TRANSMIT EXCITER

Corrections

28 JULY 2004

OZ9MO proposal to BFO-buffer.

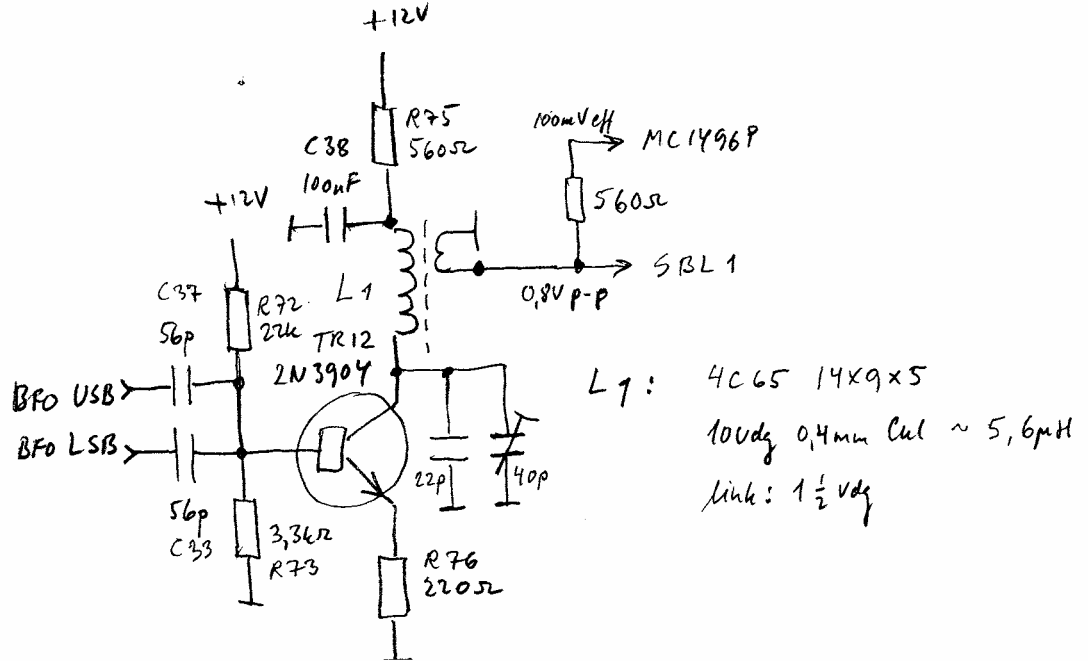
I can not get the 7 dBm out of the buffer, because the SBL1 limits at appr. 0 dBm. Without the SBL1 and with 50 ohm load the buffer delivers the required 7 dBm. Notice the series resistor to MC1496. I am using 560 ohm to get 100 mV eff to the 1496. I am using only 47 uH as RFC2. The 270 uH is a large value with the risk of having self resonance under the working frequency.

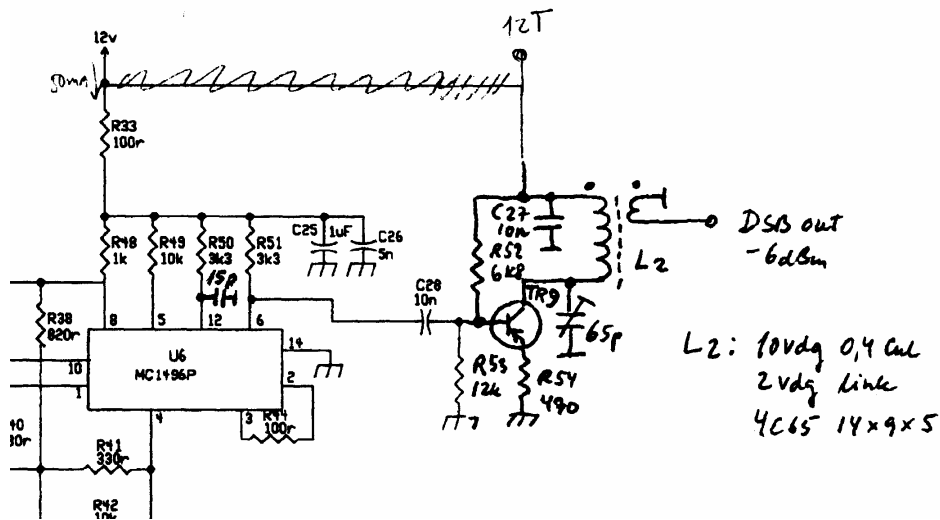
- 12 12T controls only TR9 with 12v and not U6.
- 13 Added a 100K resistor to ground.
- 14 The TX modulator was followed by an ordinary emitter-follower (TR9), but this one can not drive a 50 ohm load without distortion at levels over appr. -20dBm.

Another solution has been found, that can be mounted on the board. Now we can deliver - 6 dBm into 50 ohm with - 35 dB 2. order IM.

Notice the 15 pF that has been added to U6 pin 12. The carrier-suppression is now more constant at different levels of AF.

Mätning på modifiererat produkt-detektor. Målt över volumentpotmeter.
 Input: 2x9MHz-signaler à -26dBm.

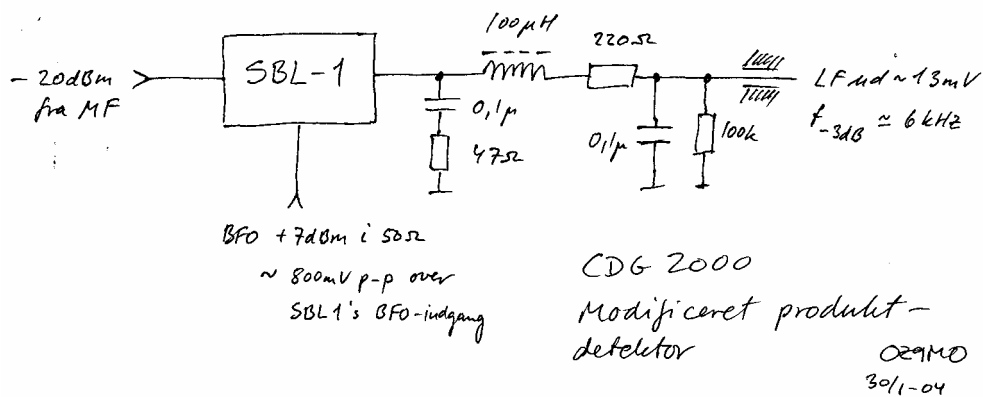
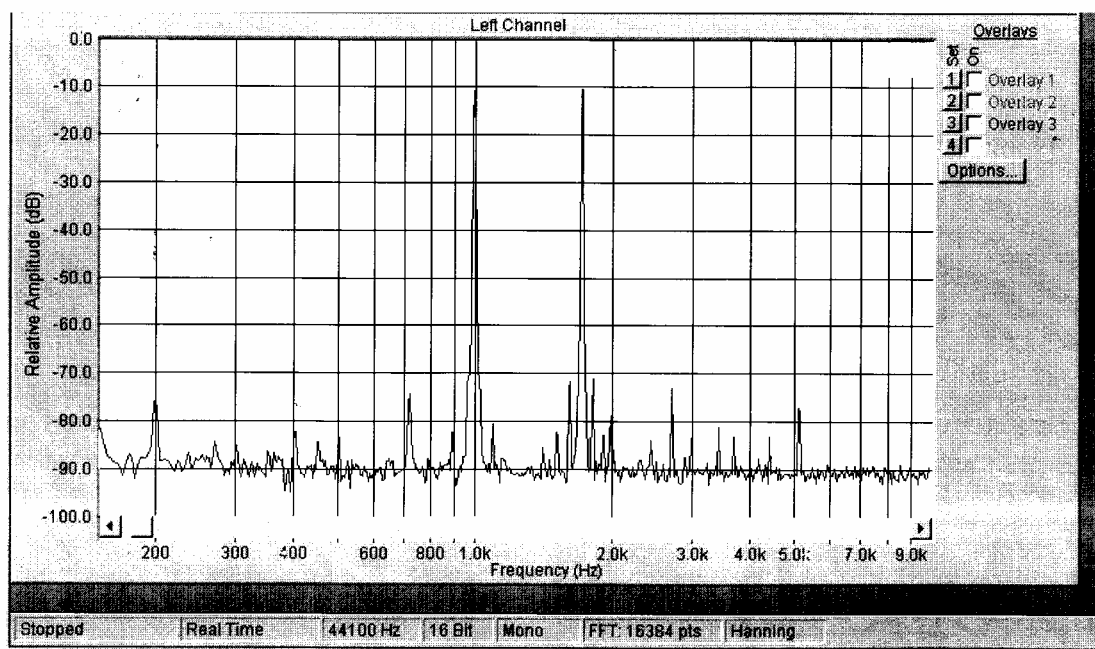
- 15 D4 and D5 are turned 180 degrees wrong on the board.
- 16 TR4 gets 12 volt via R70 on 47r, not shown on schematic.
- 17 Remember ground at R43
- 18 The Produktdetektor has been modified. The roll-off of the AF started at too low frequency. The resistor (R61) has been replaced with a 100uH choke. This correction will be changed later!!!
- 19 Proposal from OZ9MO to improve the product detector. In the proposal notice that the emitter on the AF amplifier in front of the volume control has been removed. (C19 on the CW OSC/ AF board).

Title:	CDG2000
Board:	TRANSMIT EXCITER
Revision:	A
Part:	PART 1 - VOX AND MIC AMP
Size:	A
Date:	JAN 2003
Sheet:	1 of 1

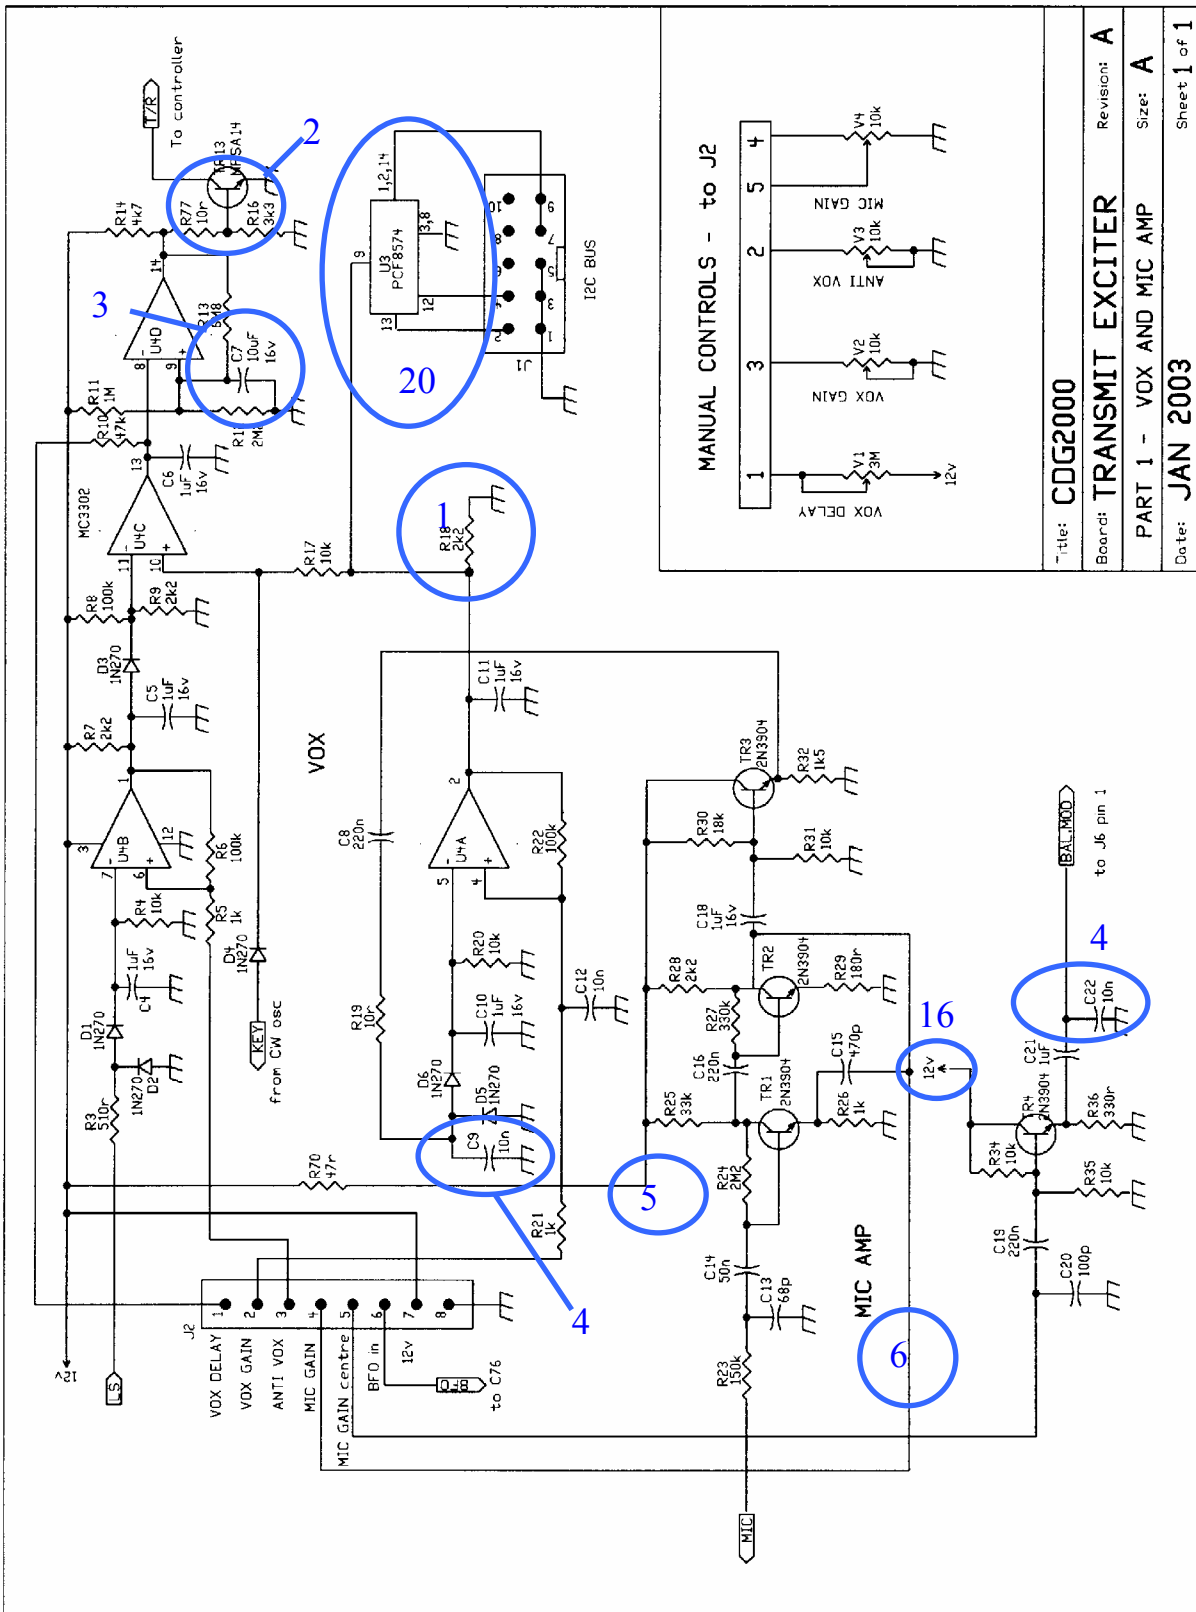
The I2C bus connection to J1 should via U3 the PCF8574 control the Vox ON/OFF. The circuit do not work

As far as I can see, the output (pin 9 of U3) will either force pin 2 of U4A to 0V or 5-10V. In both positions there will be no possibility for the Vox signal to pass to U4C. In the original circuit the Vox OFF will create a "High" at the output – but a high means Vox ON !!

So a solution to the above problems will be to add a transistor.

Remove the strap from U3 pin 9 to U4a pin 2.

Add a transistor the following way.....

Collector to Pin 2 of U4A

Emitter to Ground

Basis to pin 9 of U3 via a resistor (e.g. 1k5)

I used a BC337.

Now in position OFF a "high" from U3 will force the output of U4A to ground and no Vox is possible. In position ON a 0V output from U3 just means that the transistor is off (not conducting) and we have Vox as normal.
